MIAMI-DADE COUNTY
DEPARTMENT OF TRANSPORTATION AND PUBLIC WORKS (DTPW)

ADDENDUM NO. 2
June 24, 2022

PROJECT: Improvements to SW 87 Avenue Bridge Over Canal C-100
Project No. 20220010

- A. Volume 3 - Plans. Changes performed are enclosed in revision clouds.
- 1. Delete sheets no. 4, (Typical Section), 5 (Summary of Quantities and Pay Item Notes), 9 (General Notes), 11 (Roadway Plan), 19 (Drainage Structure Sheets), 24 (Drainage Details), 42 and 43 (Canal Cross Sections), 45 (Slope Protection Detail), 59 (Bridge Summary of Quantities), 60 (Plan and Elevation), 62 (Foundation Layout), and 63 (Pile Data Table), and replace with the attached Revised Sheets for Addendum No. 2.
 - 2. Add new sheet from the attached 48in Water Main for Addendum No. 2.
 - 3. Add new sheets from the attached FPL Pole Locations for Addendum No. 2.

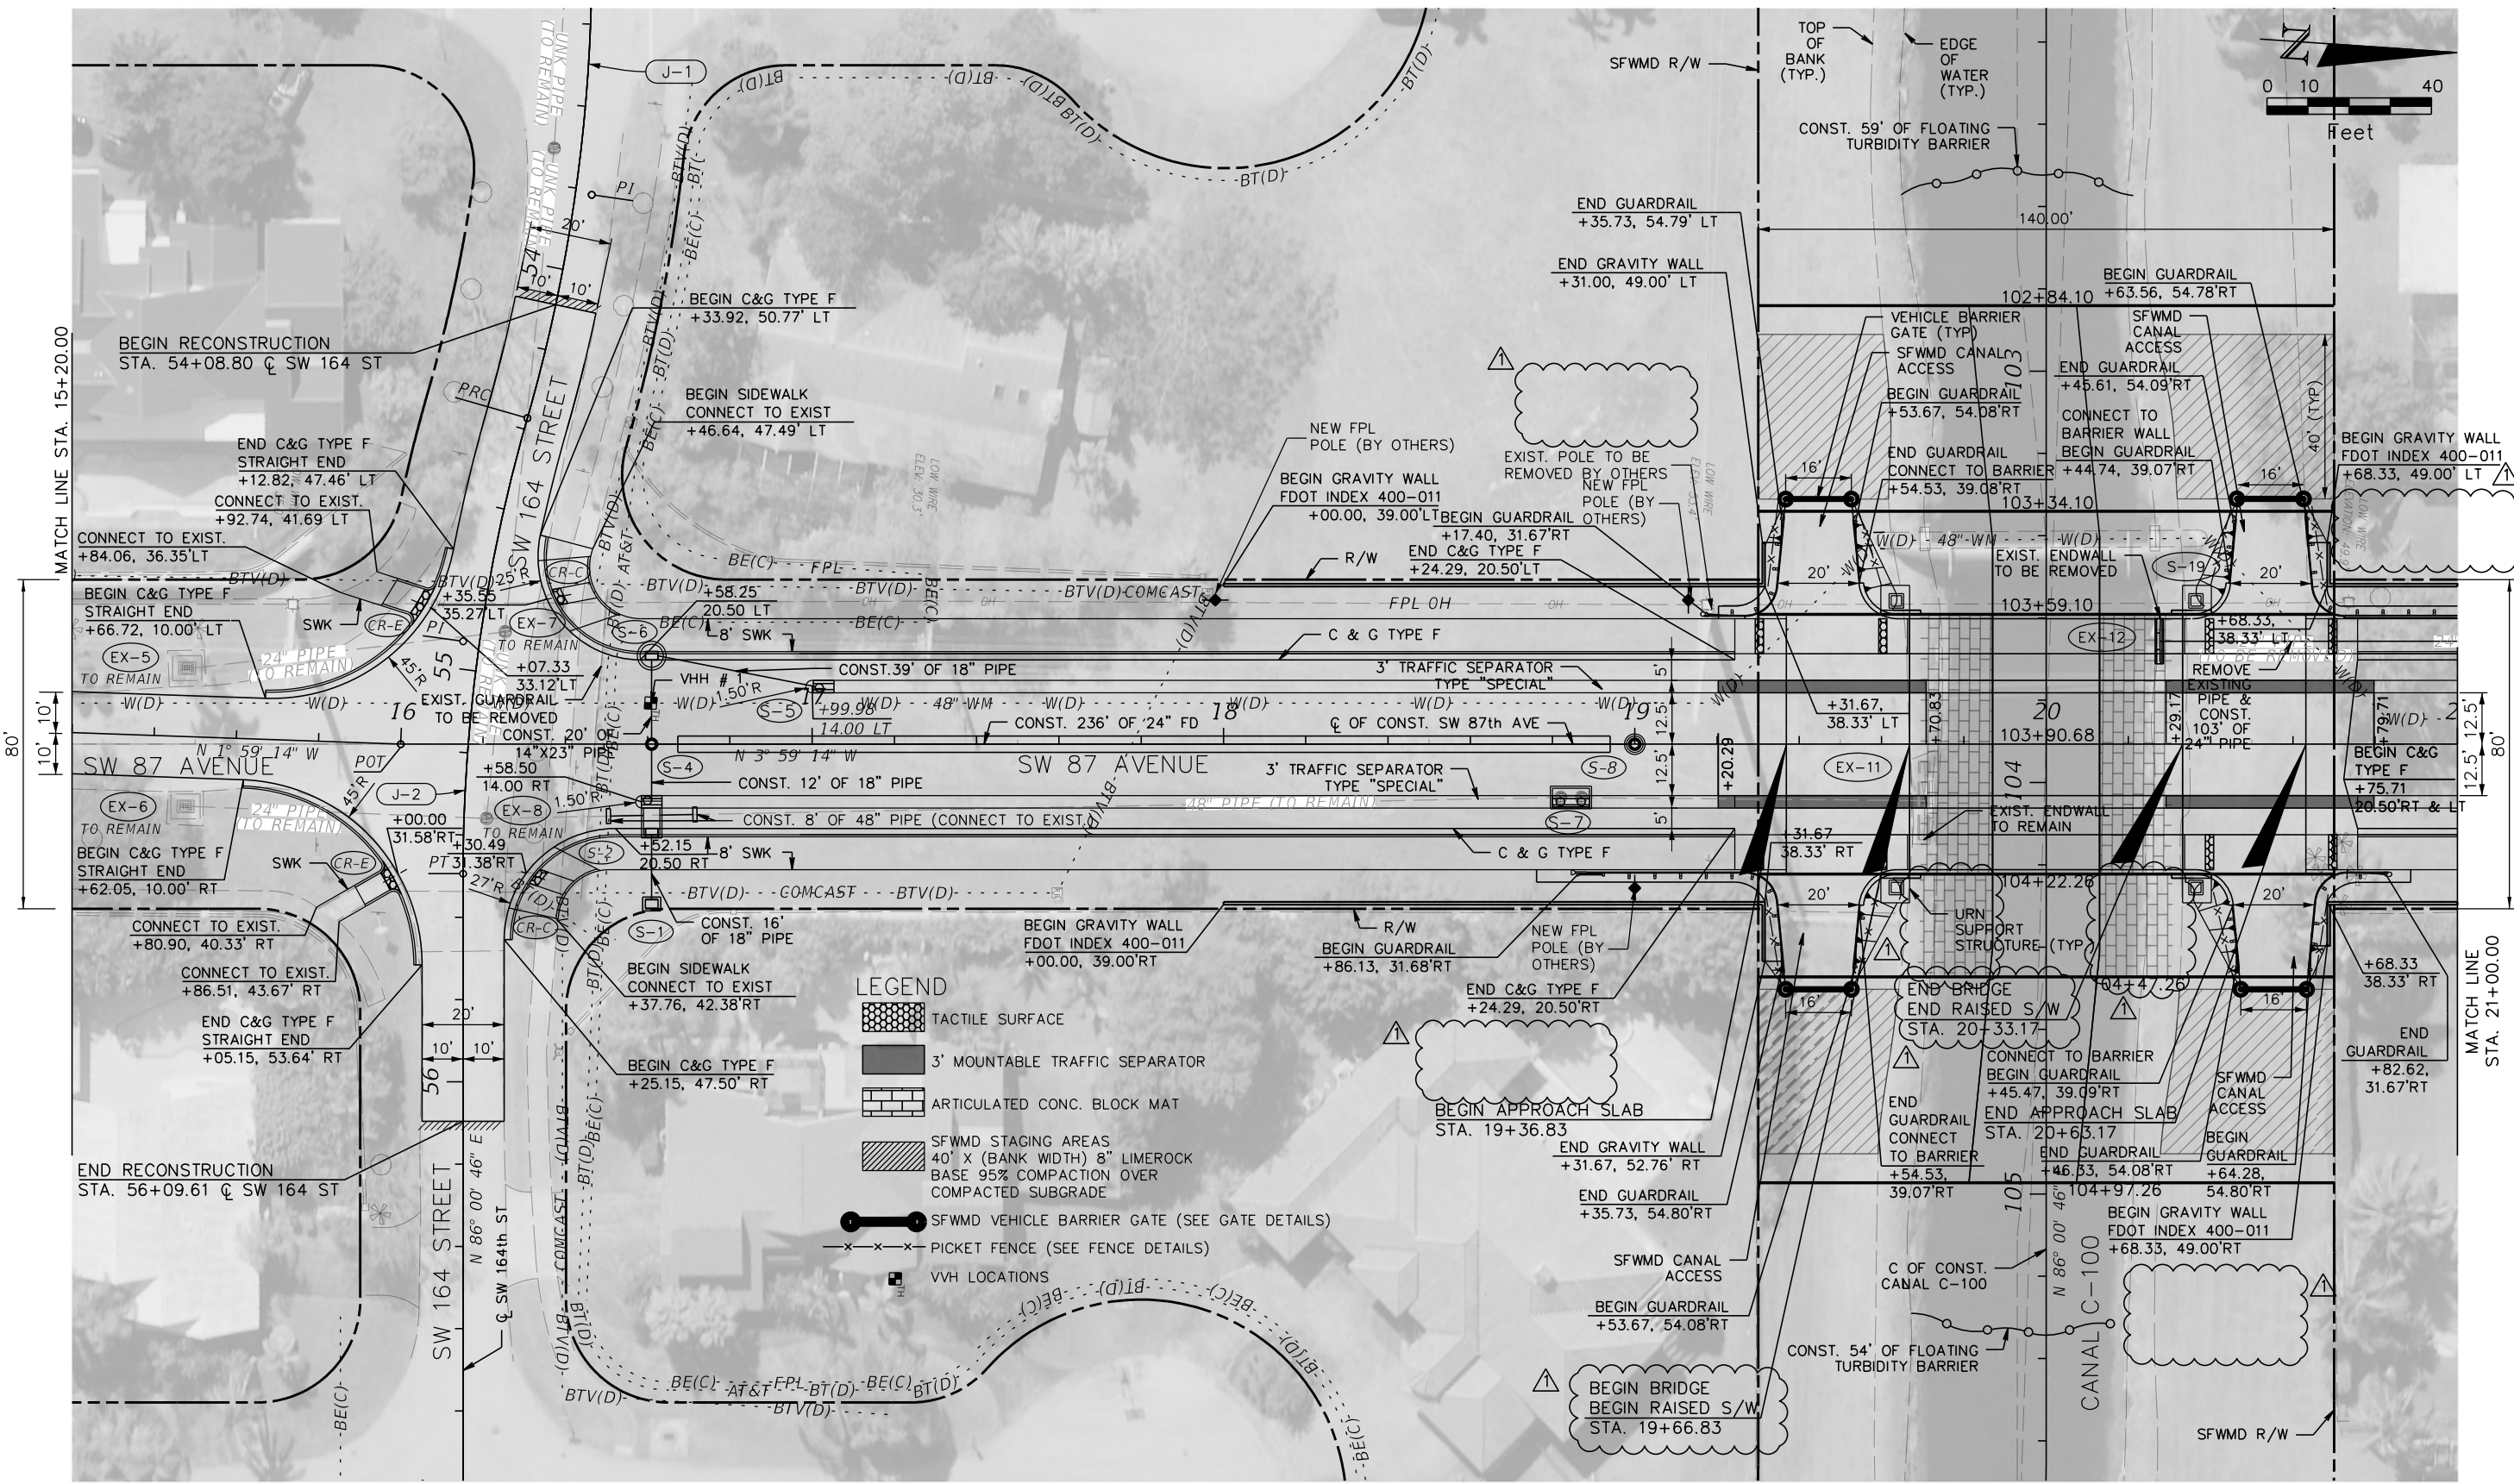
REVISIONS					
DATE	BY	DESCRIPTION	DATE	BY	DESCRIPTION
6/23/22	JC	REMOVED & ADDED LABELS ADDED

DRAINAGE STRUCTURE SHEETS

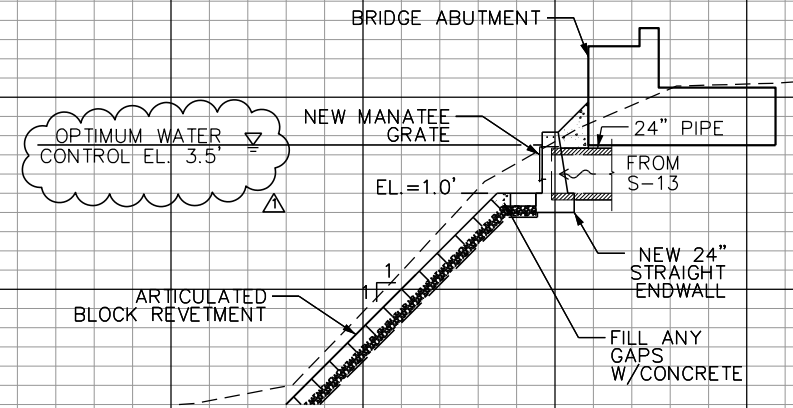
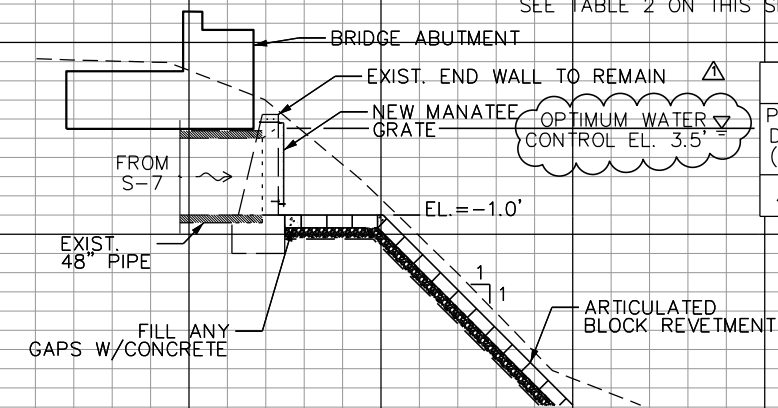
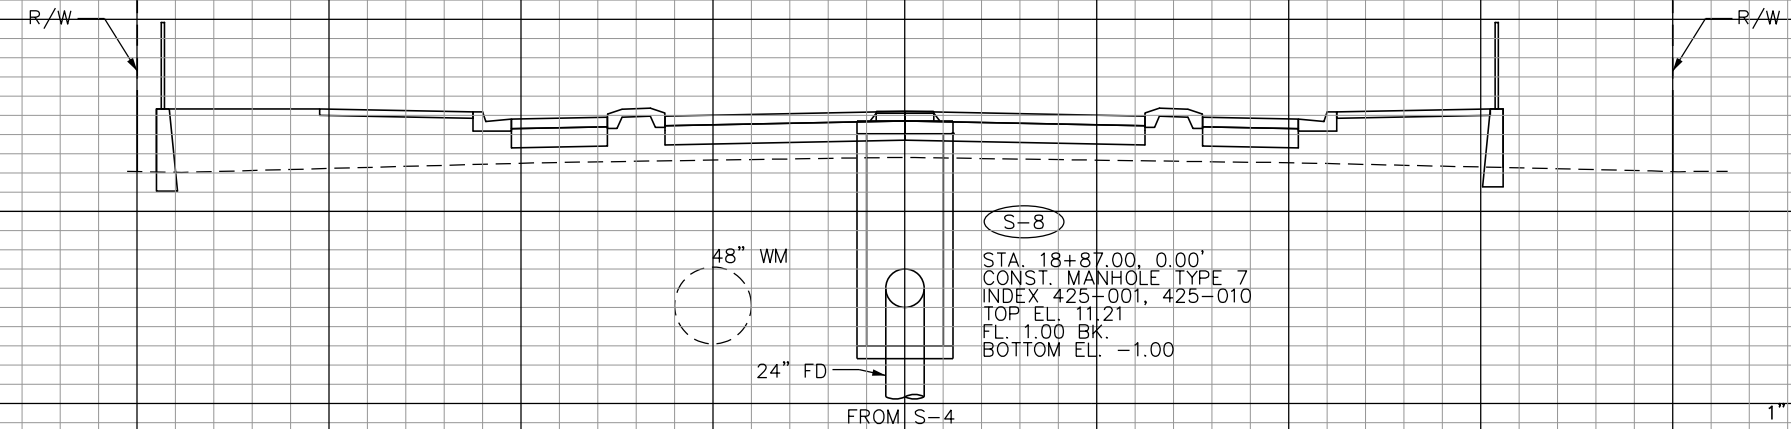
REVISIONS			REVISIONS		
DATE	BY	DESCRIPTION	DATE	BY	DESCRIPTION
6/23/2022	JC	ADDED OPCE INFORMATION

S-15 SECTION A-A'
N.T.S.

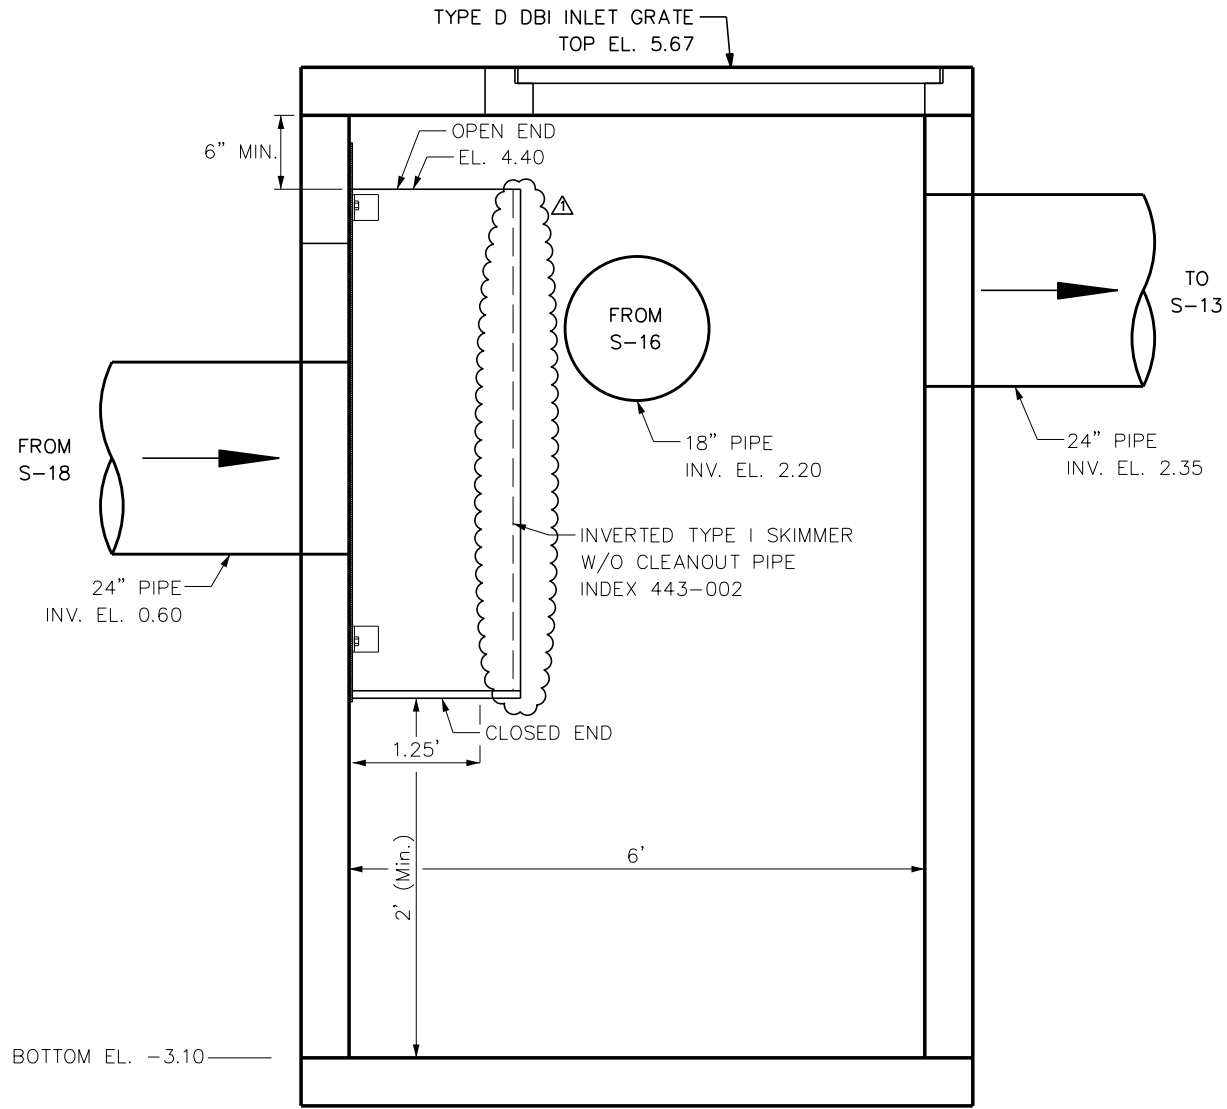
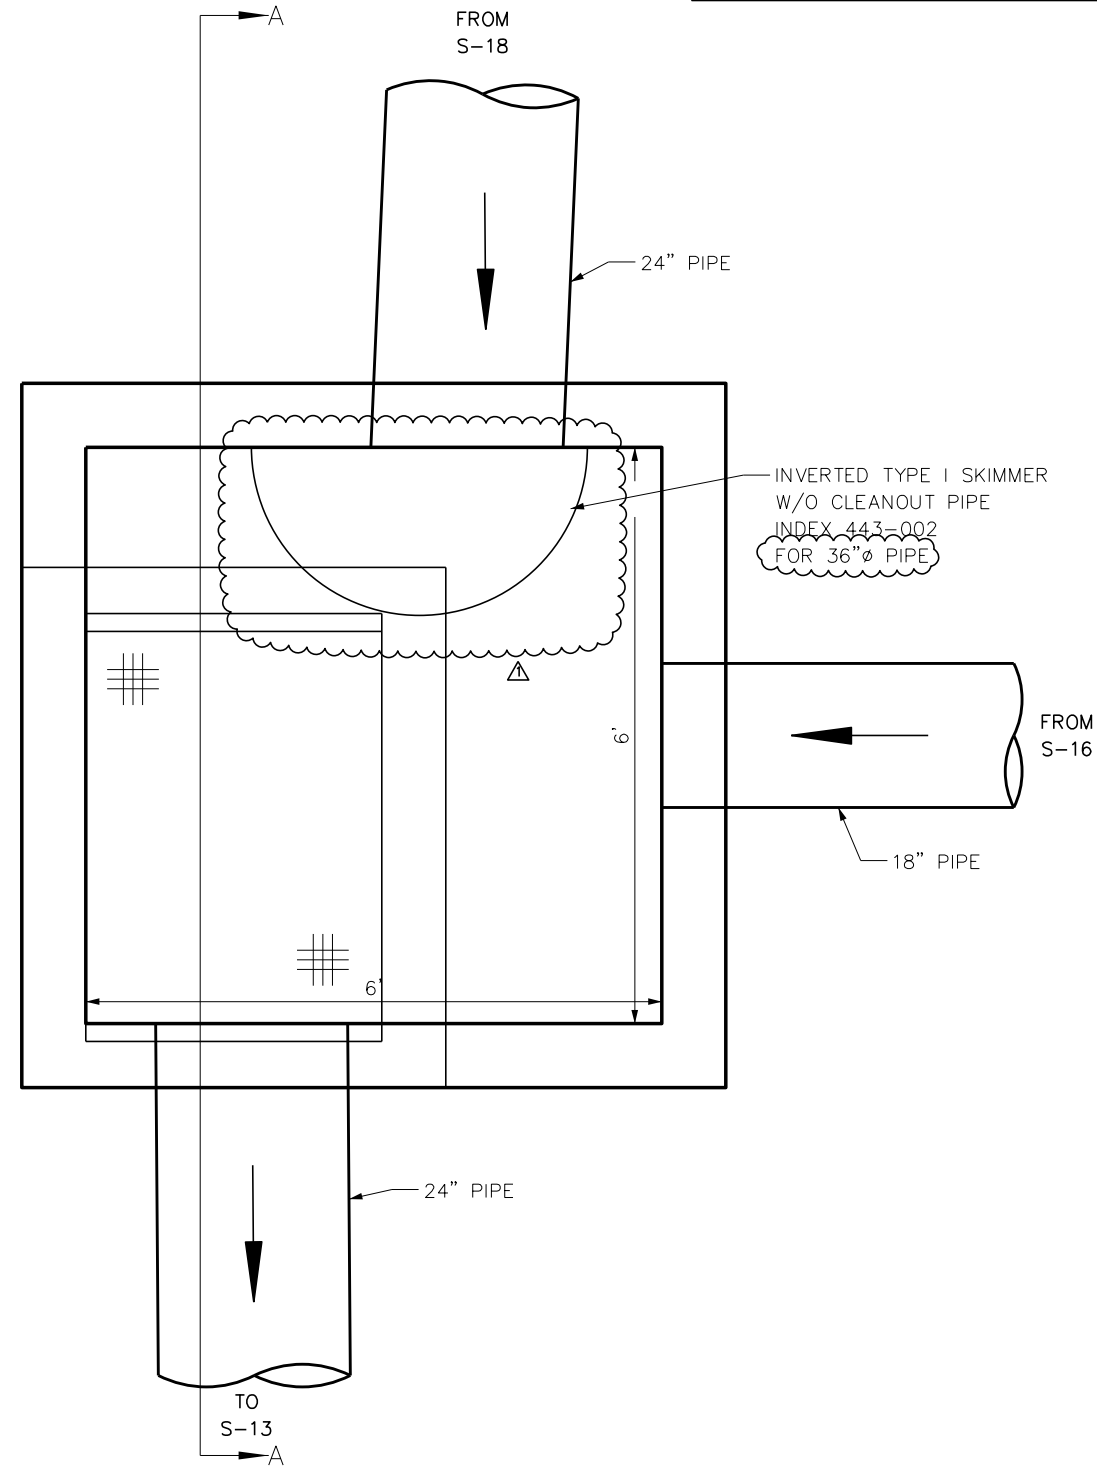
R E V I S I O N S								
DATE	BY	DESCRIPTION	DATE	BY	DESCRIPTION	DATE	BY	DESCRIPTION
6/23/2022	JC	REVISED SIZE OF WEIR

CANAL CROSS
SECTIONS

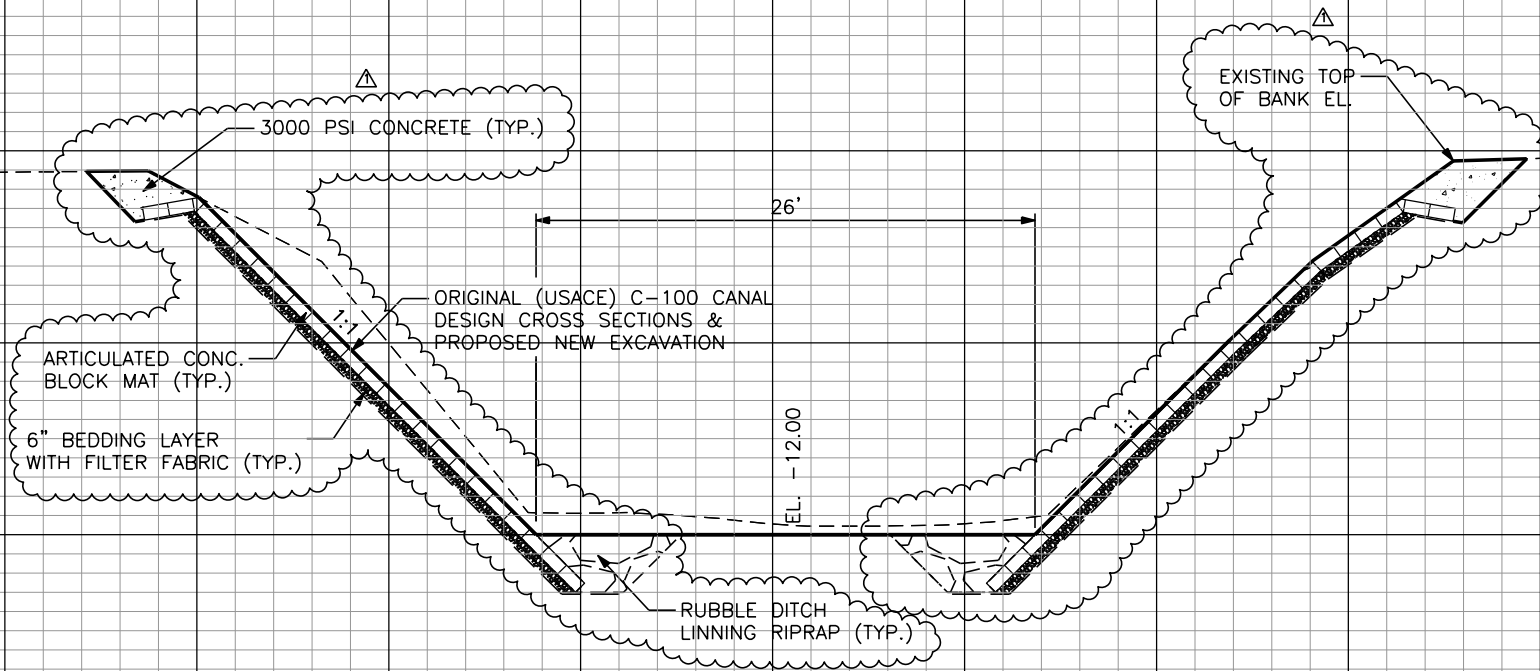
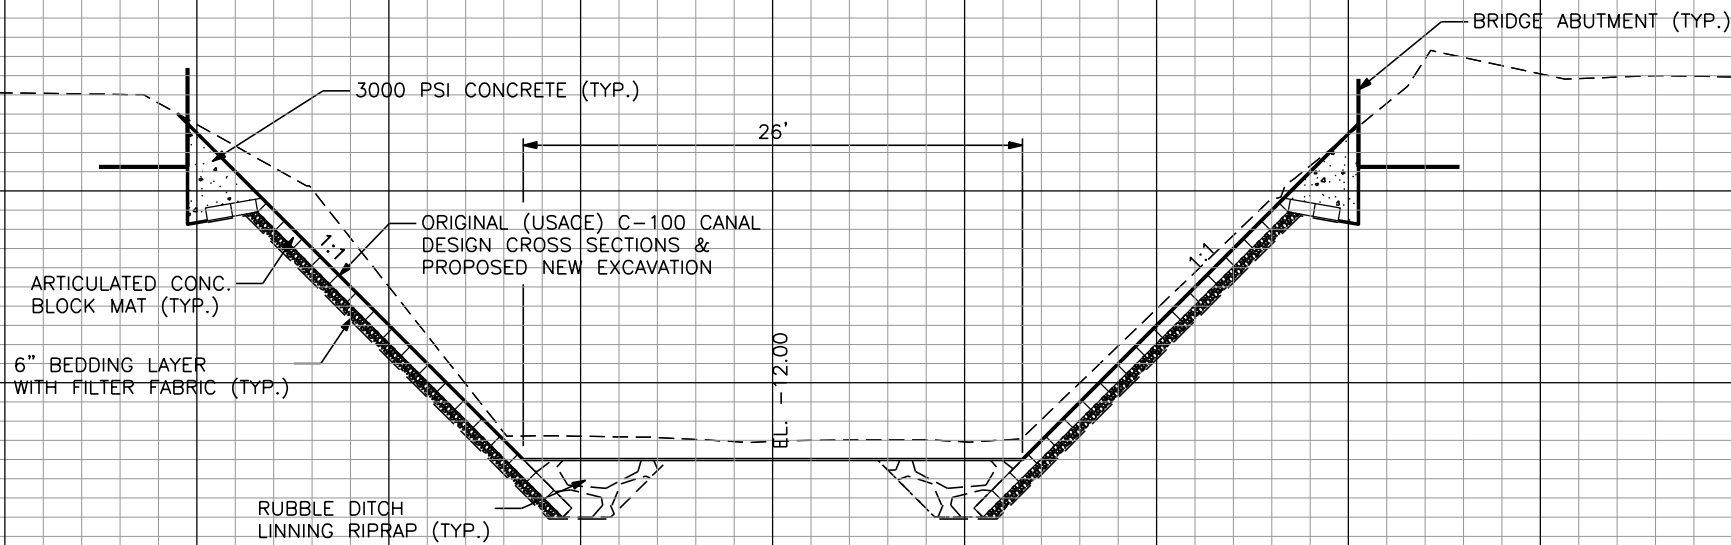
REVISIONS					
DATE	BY	DESCRIPTION	DATE	BY	DESCRIPTION
6/23/2022	JC	REVISED QUANTITIES
